TECHNICAL BULLETIN

[Issue No.] GOT-A-0082

[Title] Changes of the RS-232, RS-422/485, and Ethernet interfaces for the GOT2000 series GT27 models

[Relevant Models] GOT2000 Series (GT2715, GT2712, GT2710, GT2708)

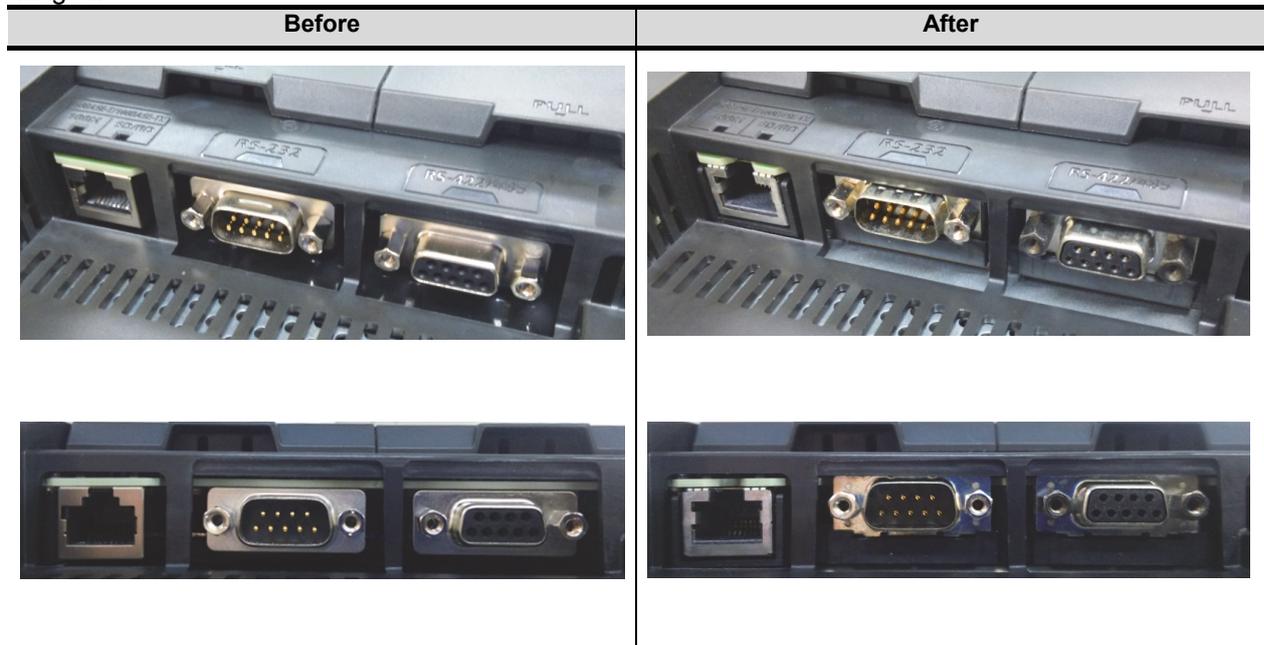
The appearances of the RS-232, RS-422/485, and Ethernet interfaces and their surrounding structures are changed.

2. Details of Changes

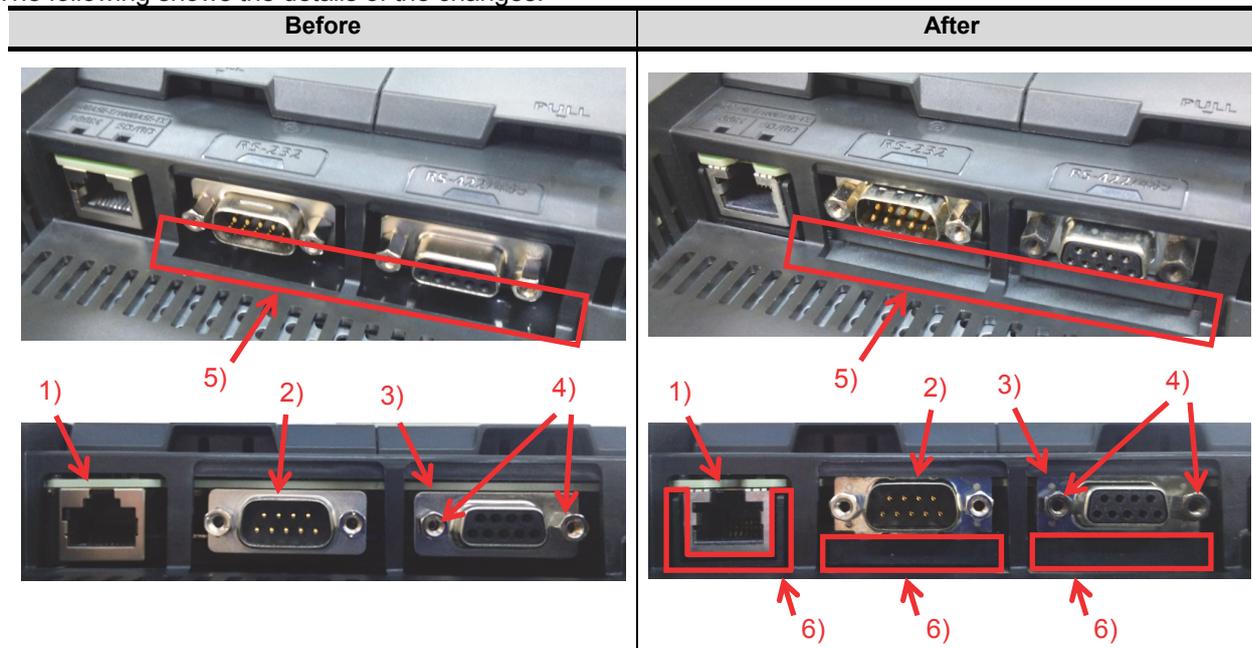
- 1) The appearance of the Ethernet interface is changed.
- 2) The appearance of the RS-232 interface is changed.
- 3) The appearance of the RS-422/485 interface is changed.
- 4) The color of the screw fastening portion of the RS-422/485 interface is changed from silver to black.
- 5) The color of chassis at the lower part of the RS-232 and RS-422/485 interfaces is changed from black to silver.
- 6) A plate is newly added around the RS-232, RS-422/485, and Ethernet interfaces.
